Forsyth County Procurement

ADDENDUM #6

RFP 20-78-1620

For: Providing all labor, equipment and materials for the construction of a new Juvenile Justice Center at 875 Lanier 400 Parkway, Cumming, GA 30040. Project includes a multi-phased site development, demolition of existing motel structures and construction of new 62,000 square foot Juvenile Court building.

Sheet No.:
ID-2.51

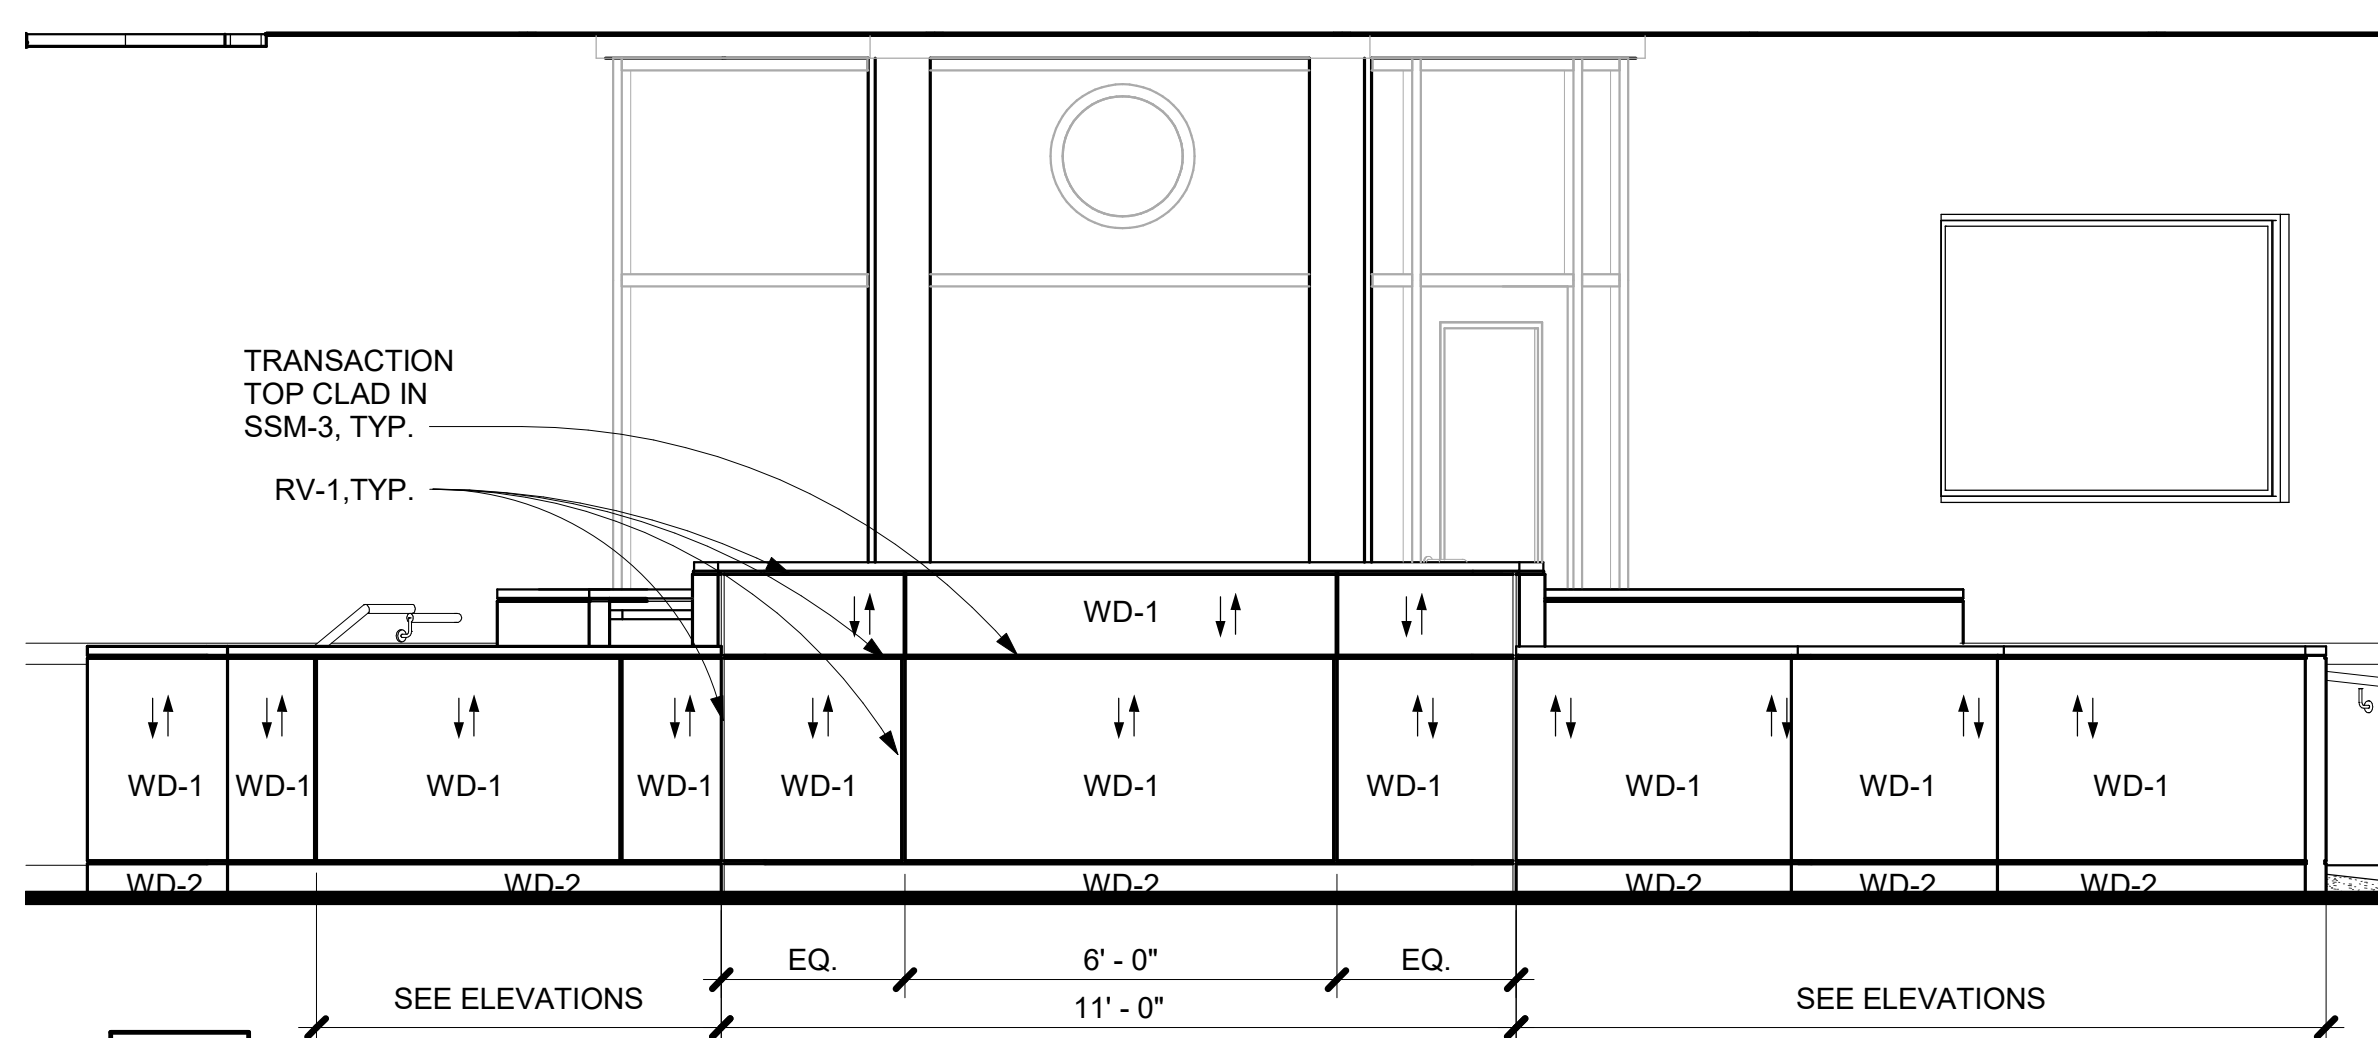
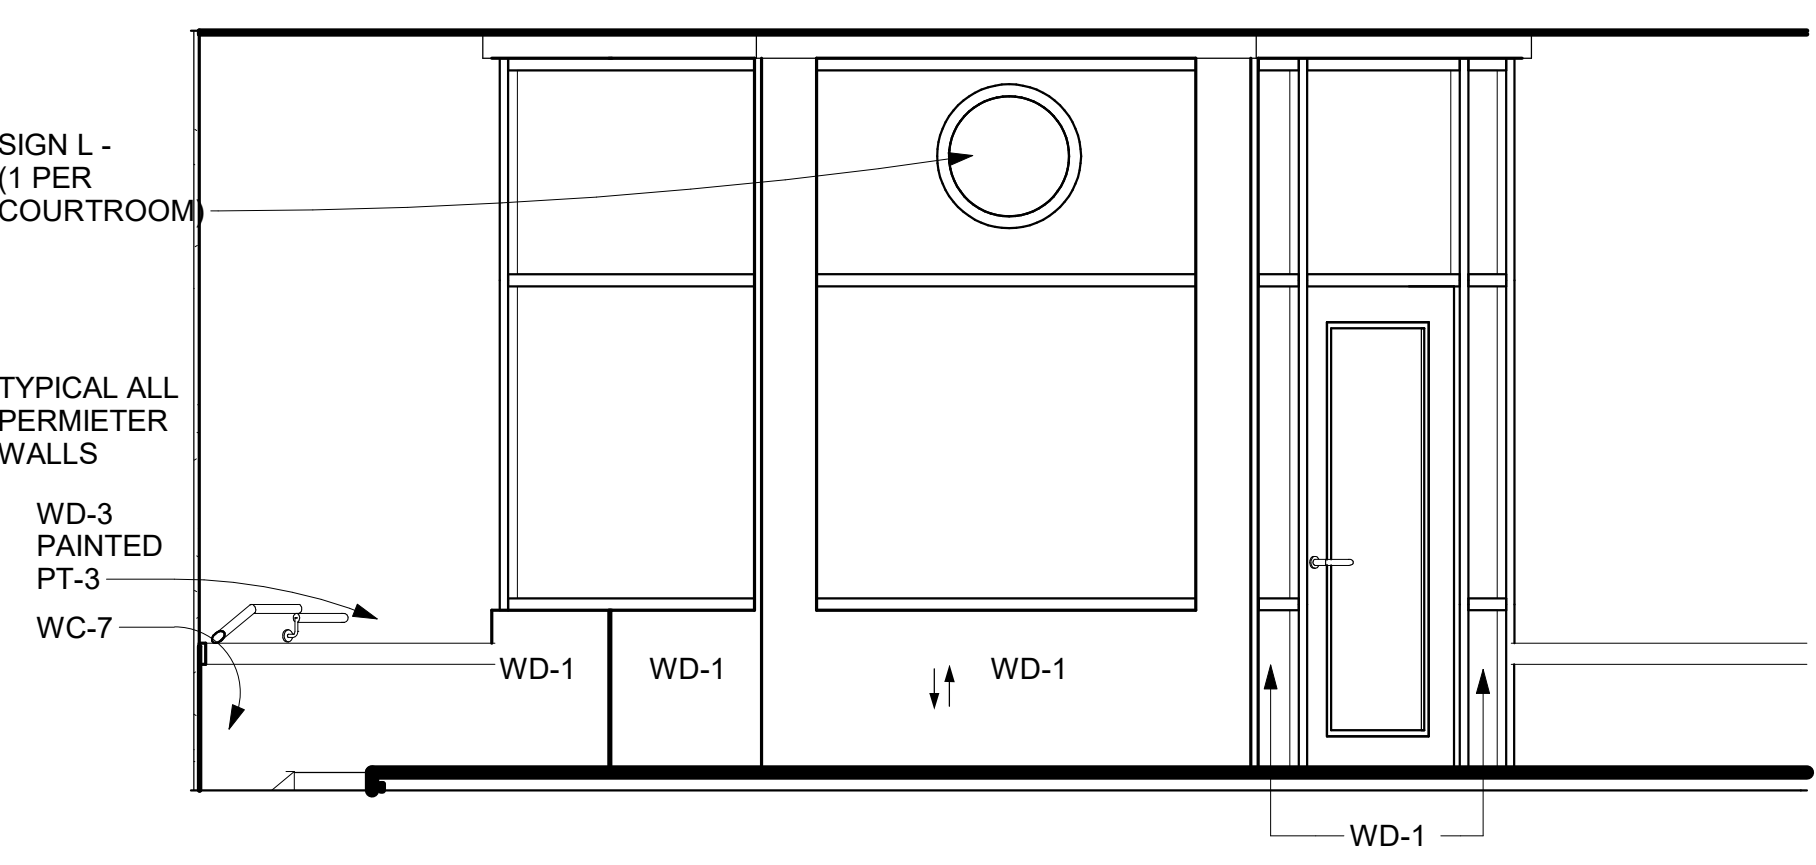
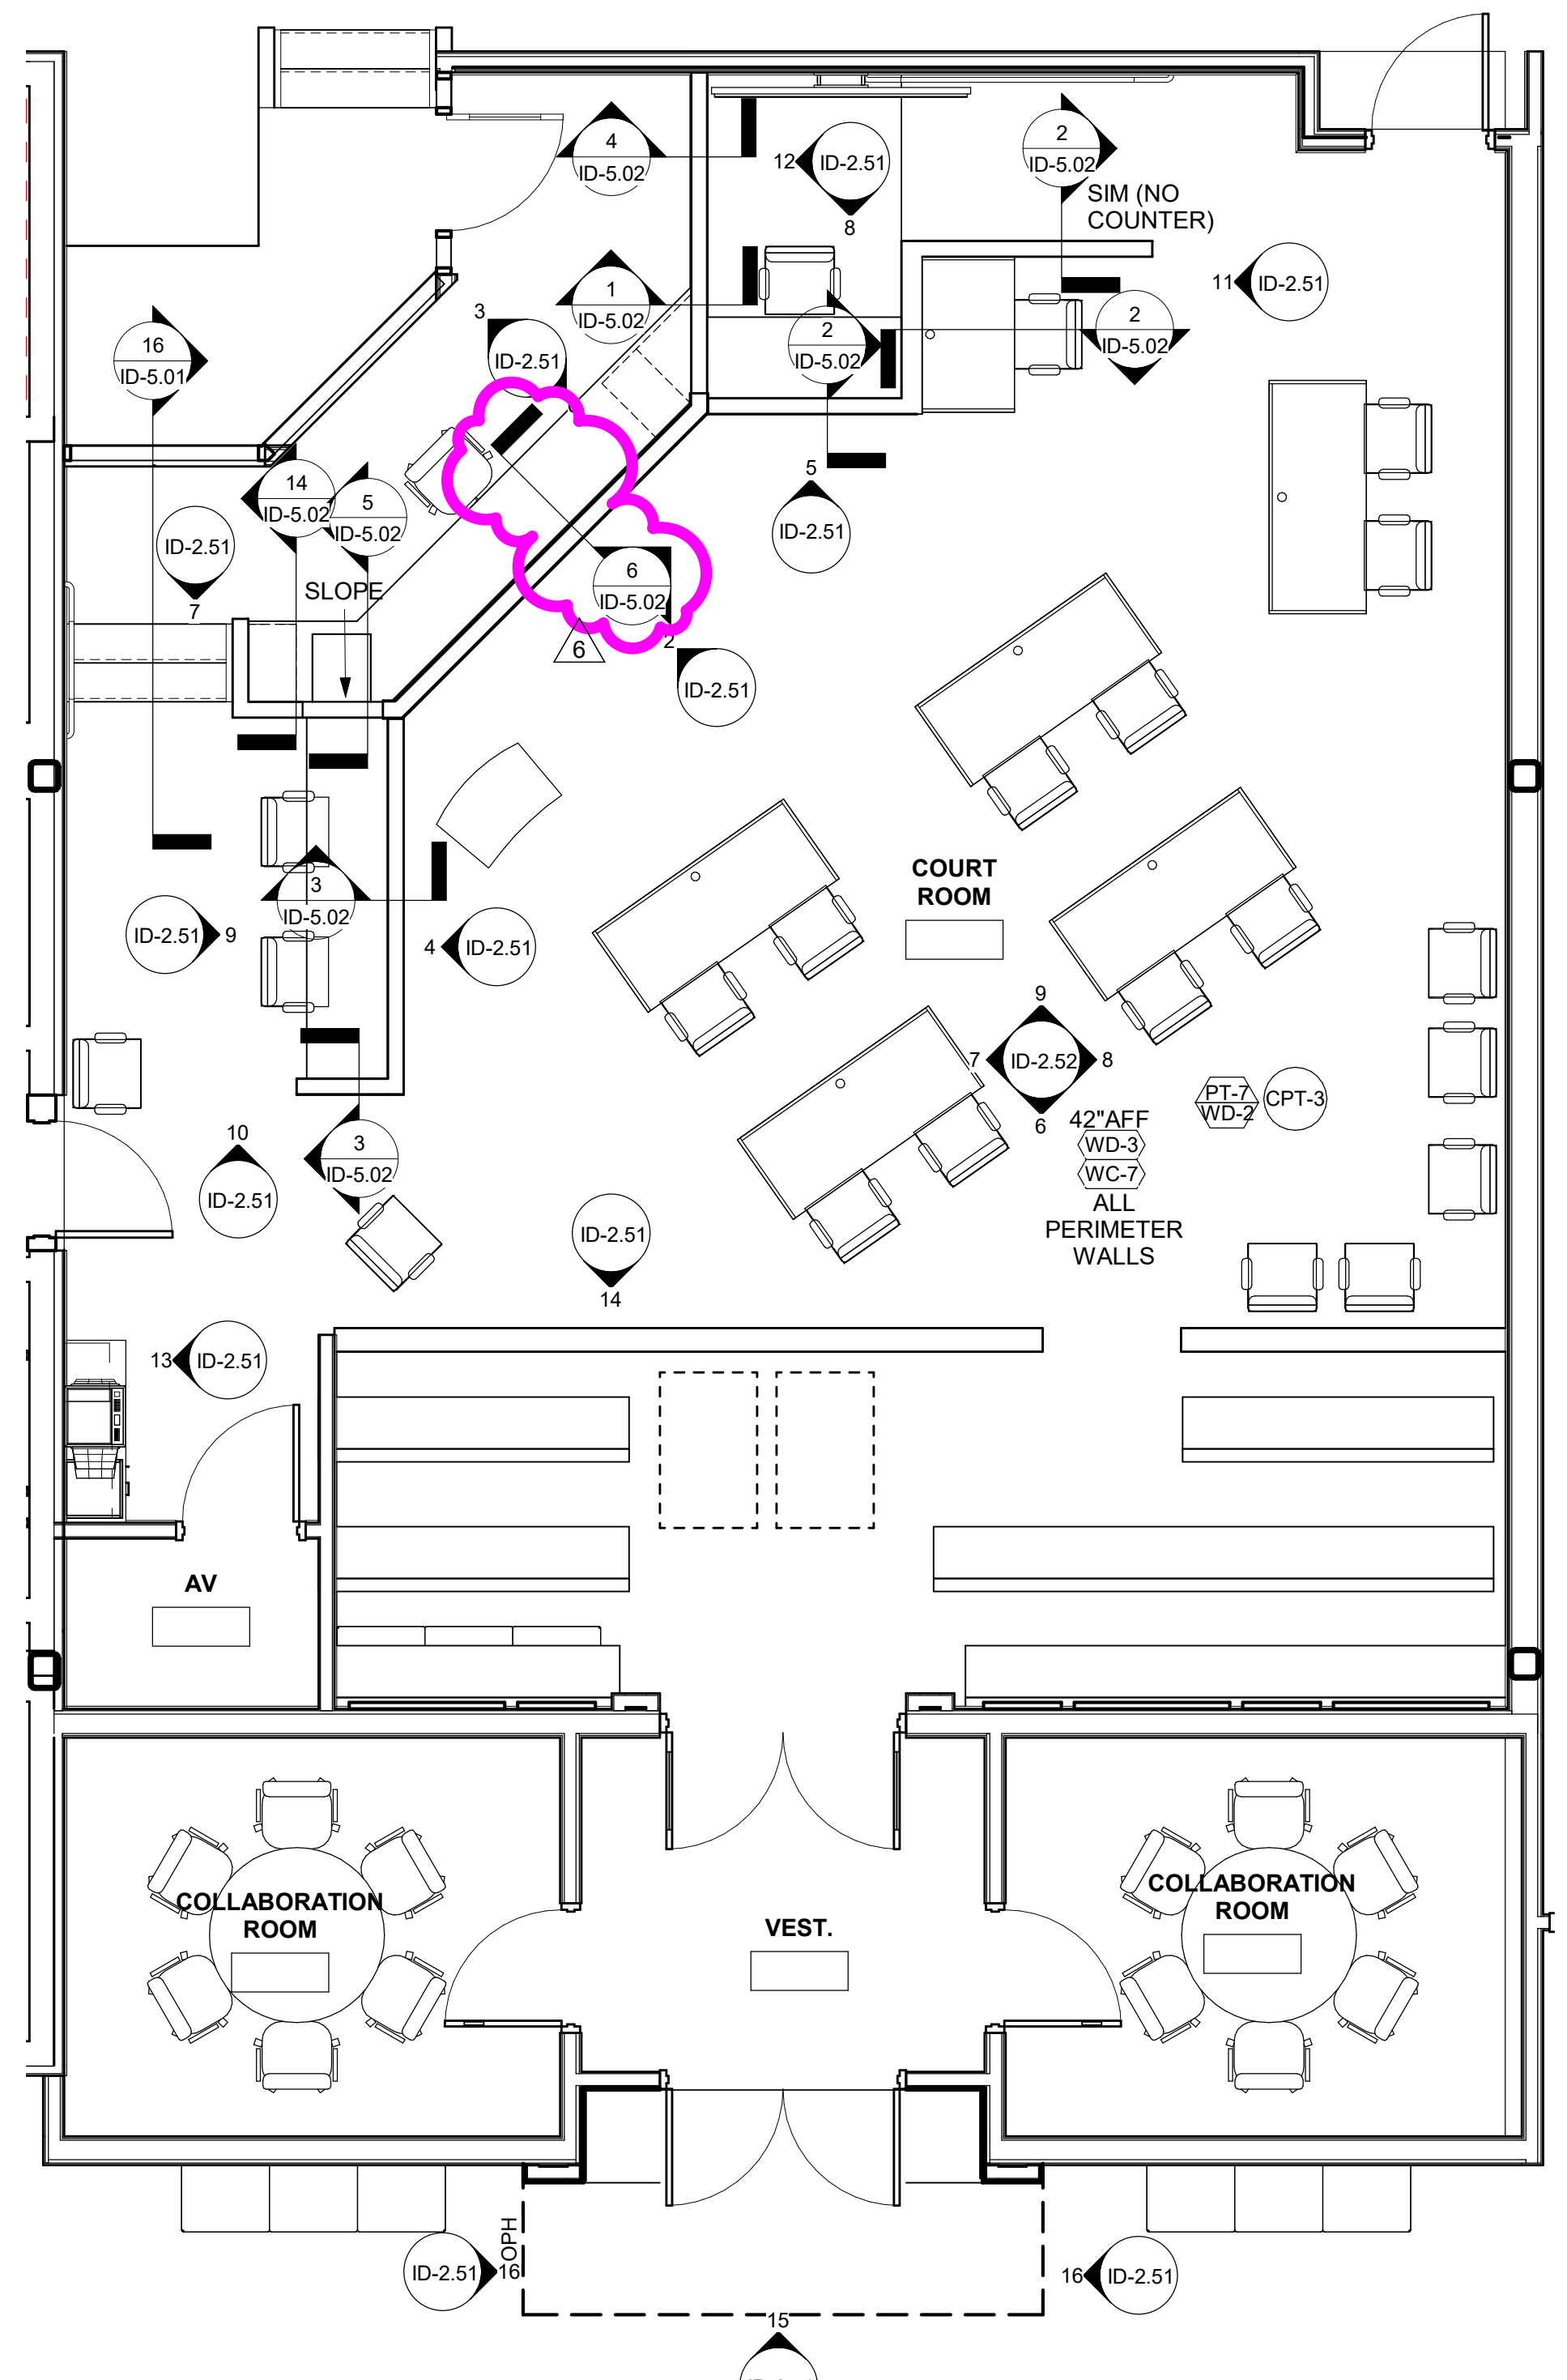
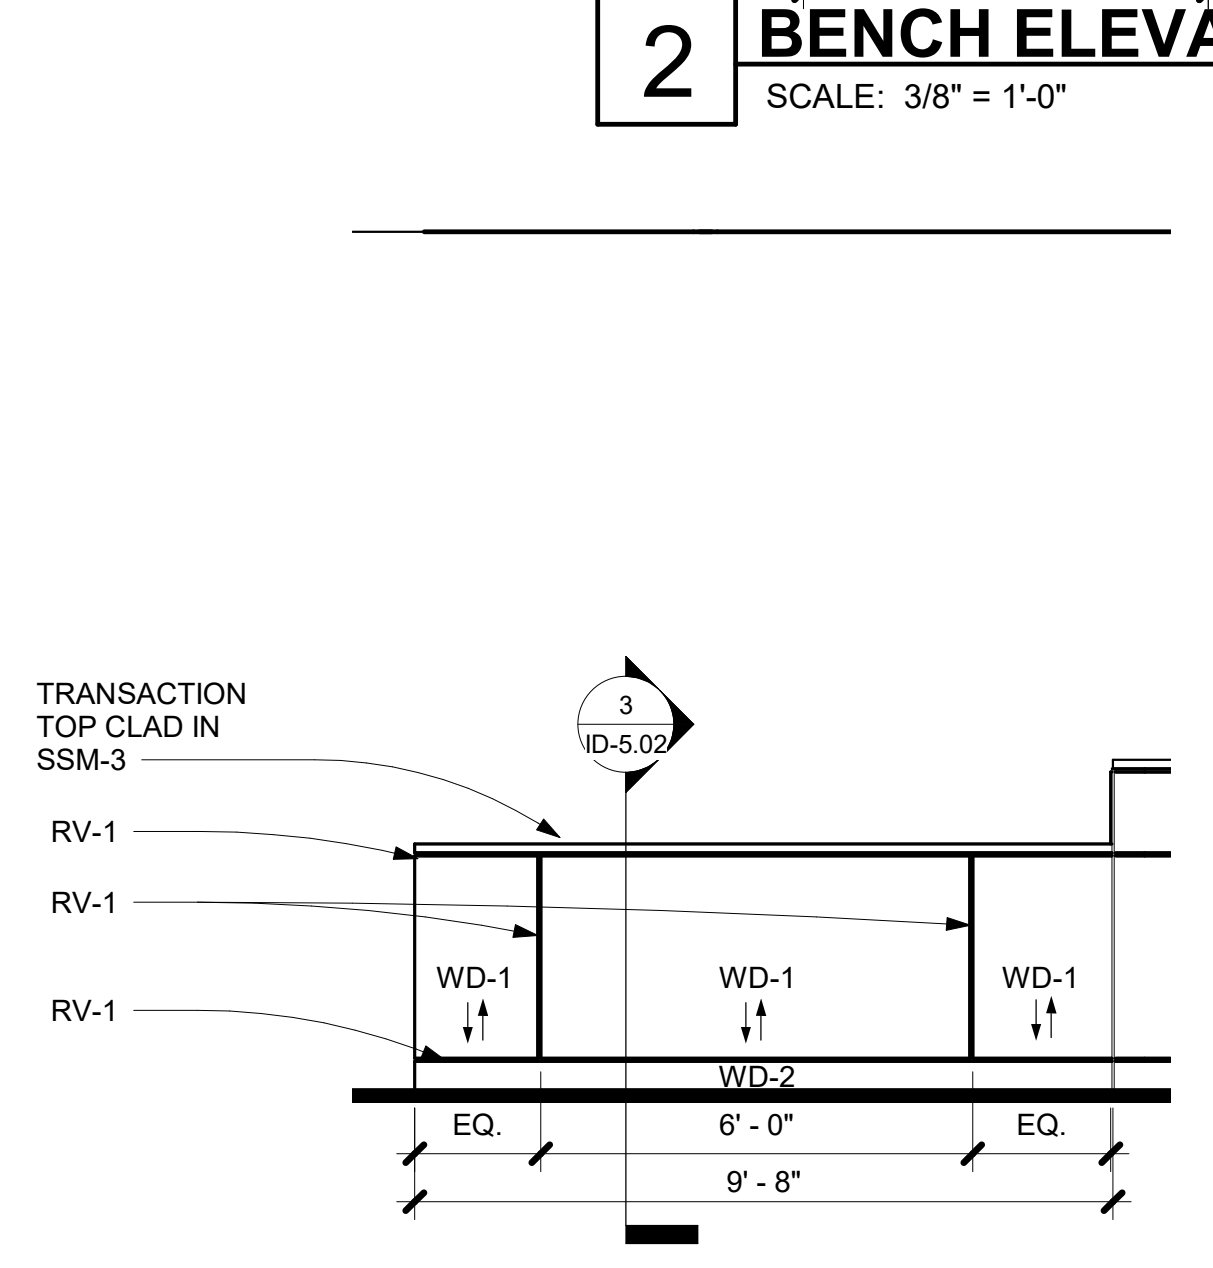
- a. **RESPONSE: *Update drawings to address clarifications released under Addendum 6***
9. Please confirm that detail 6/ID-5.02 is located at the front of the judge's bench (elevation 2/ID-2.51). In addition, please confirm that bullet-resistant panel infill is not required at details 2 & 3 on ID-5.02.

1. Section cut added to the Judge's Bench.
2. Reference sheet ID-2.51 ENLARGED FINISH PLANS & ELEVATIONS released under addendum #06 dated 07/16/2020.

- a. **RESPONSE: *Yes, detail 6/ID-5.02 is located at the front of the judge's bench (elevation 2/ID-2.51). Bullet-resistant panel infill is not required at details 2 & 3 on ID-5.02.***
